Idaho Department of Environmental Quality
2110 Ironwood Parkway
Coeur d'Alene, ID 83814
December 12, 2005

Subject: Avery Landing
Soil, Ground Water and Surface Water Contamination and Remedial Efforts to Date
Avery, Idaho

Figure 2. Monitoring Well, Excavation Trench and Containment Wall Location Map

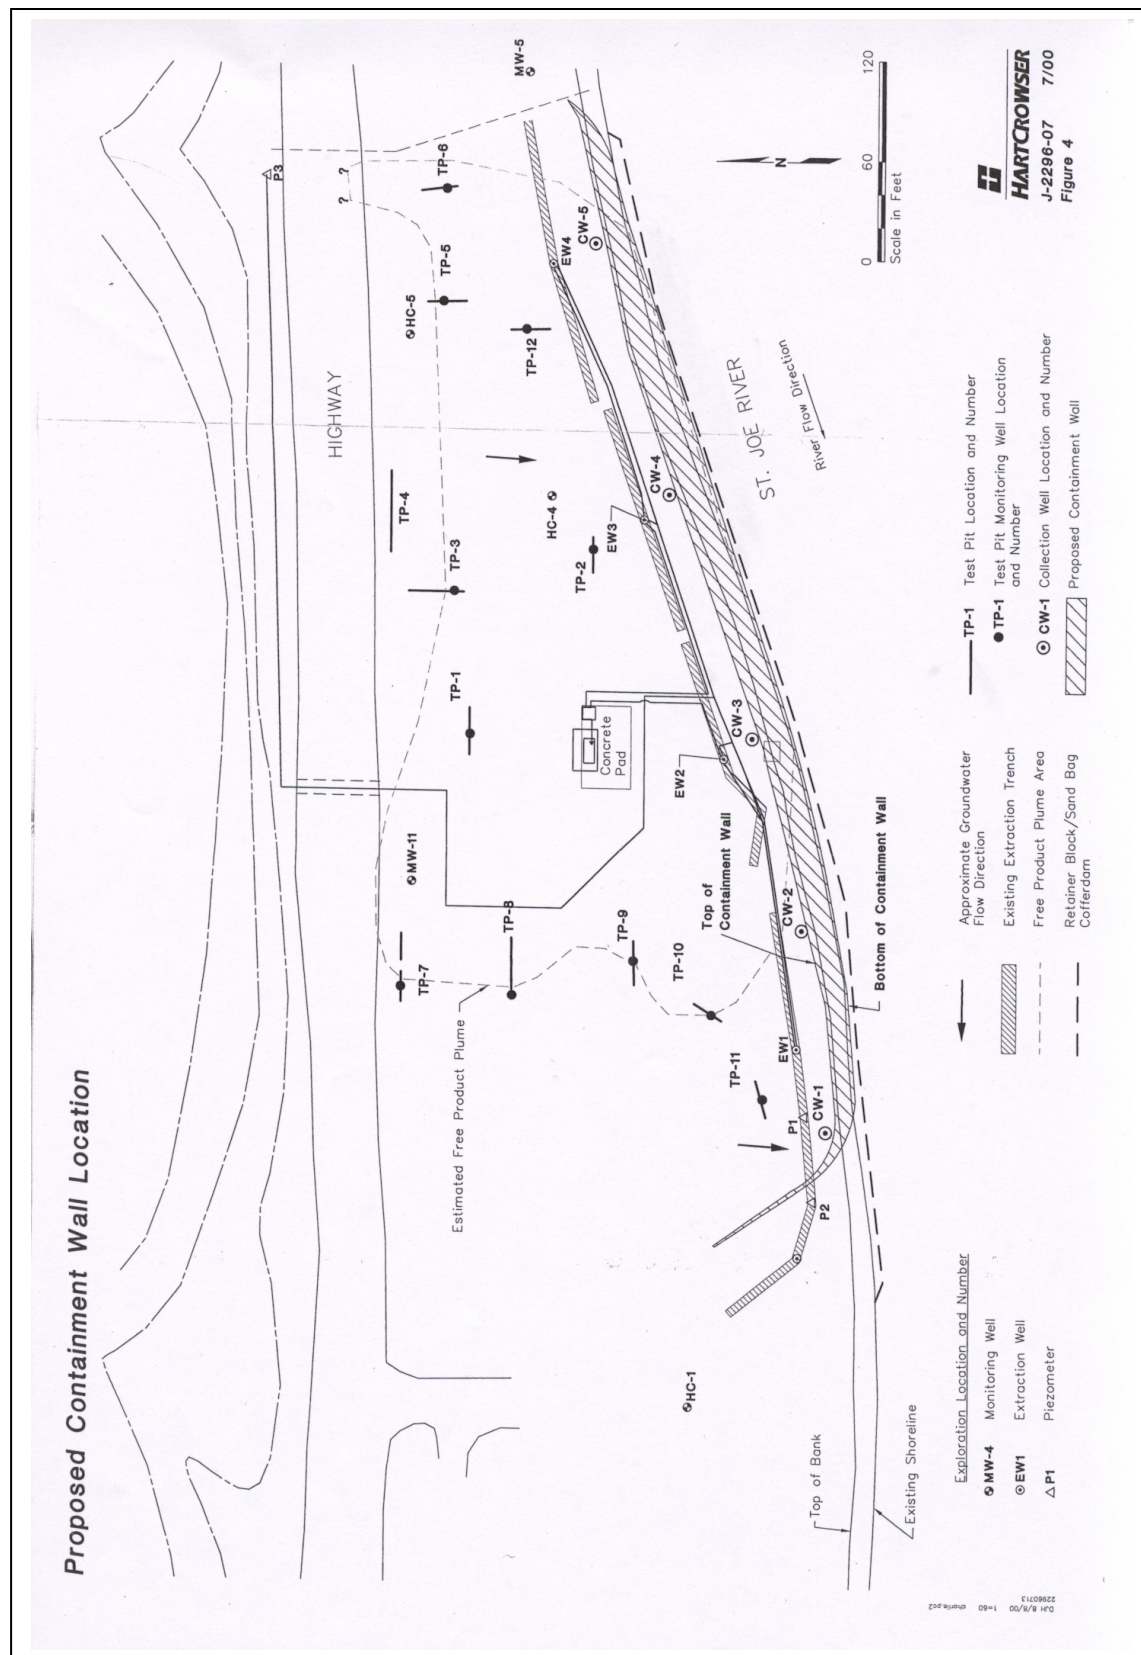
1. HC completes seven monitoring wells (HC1 – HC5, MW-5 and -11), three piezoimeters (P1-P3), 11- test pit monitoring wells (TP1-TP12), and four extraction wells (EW1 – EW4) (see Figure 2 for well location). The exact timing, sequence and construction of these wells are unknown based on the available documentation. Some wells have apparently been destroyed or made unusable.
2. Through the completion of subsurface explorations it is determined that there is a significant quantity of what appears to be Bunker C fuel oil at the ground water interface. It is reported that HC4 there was a 4-foot thick free phase product thickness.
3. The extent of the contaminated ground water can be seen in Figure 2. The ground water sampling mainly consisted of obtaining depth to ground water and the thickness of free product. The latest sampling event

4. HC determined that in order to maintain the petroleum hydrocarbon on site a recovery system was proposed and constructed. The recovery system consisted of a down gradient cutoff trench with extraction wells completed in the trench. The cutoff trench would capture petroleum contaminated water and then pump the water through the extraction wells to an oil/water separator. The treated water would then be pumped to an upgradient location and reinjected into the ground water system through infiltration trenches. Apparently the product from the oil/water separator would be pumped to a separate holding tank for removal. (See Figure 2).

The current remedial design treats the water through an oil/water separator and then re-injects that water into an up gradient infiltration trench (see figure 2). Given the potential quantity of water produced and the lack of disposal options this may be the only alternative. The city of Avery does not have sewage treatment

Figure 3. Avery Hill and Culvert Location Map

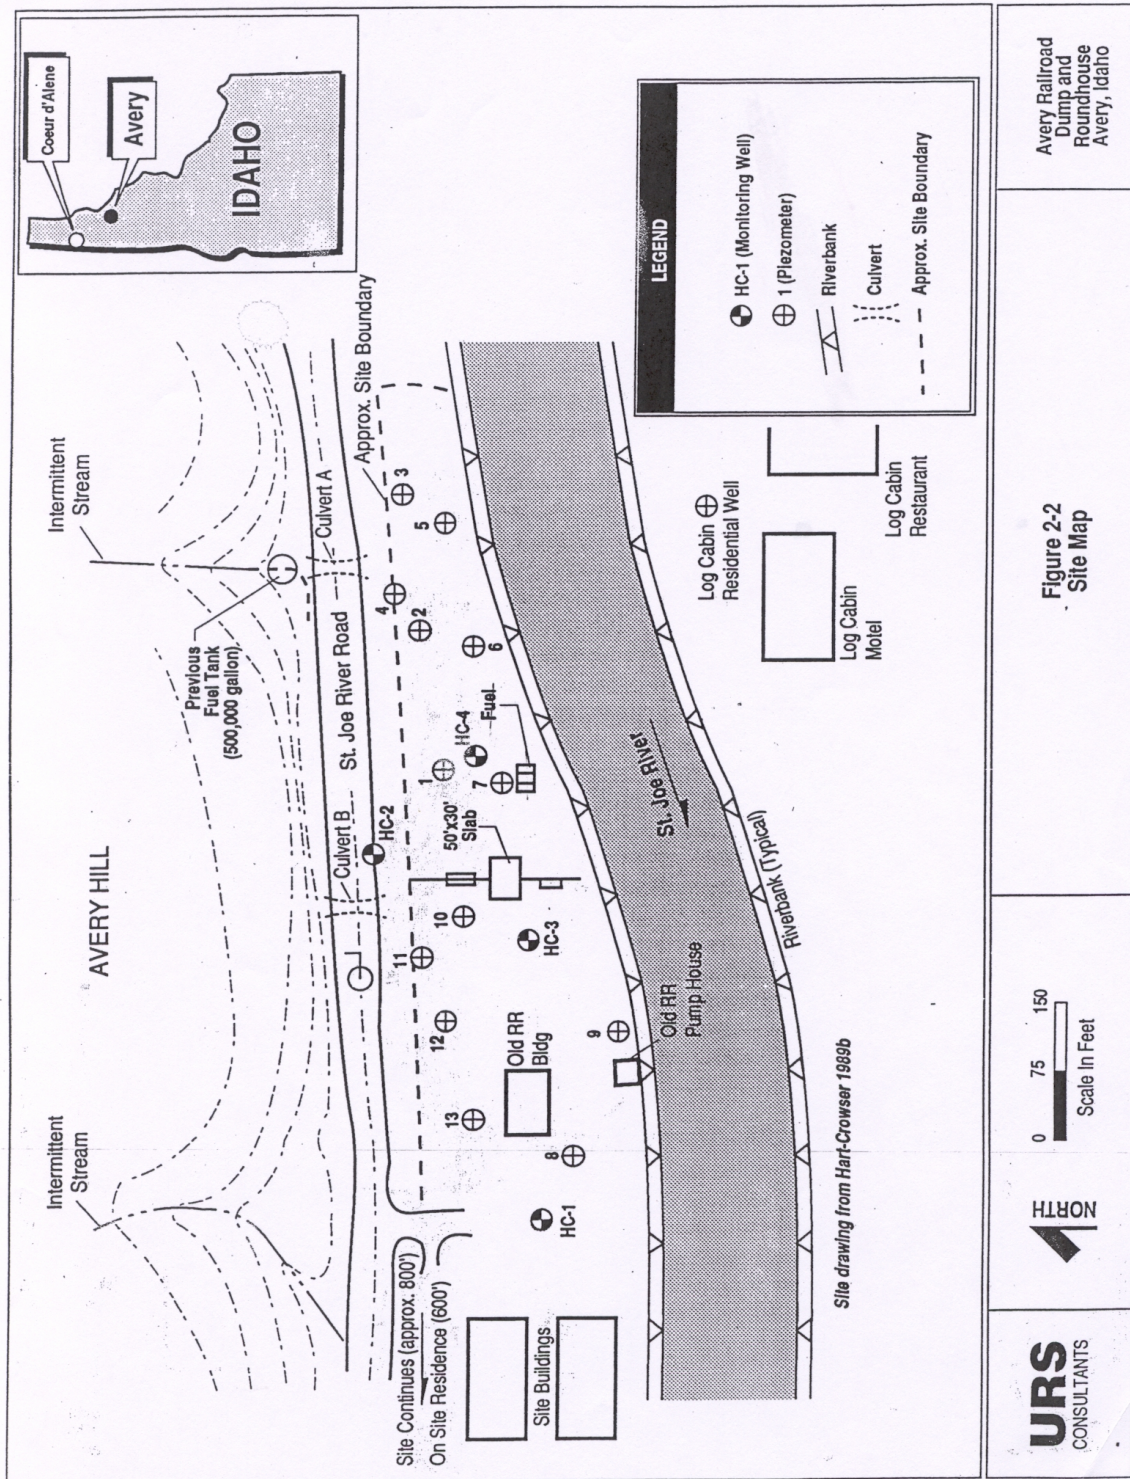
There are two culverts which drain runoff from the adjacent upland areas onto the surface of the site (Figure 3). The culverts should be diverted off-site to reduce the amount of water flowing through the soil and possibly reduce the leaching of product to the ground water. The following entities would most likely be involved:
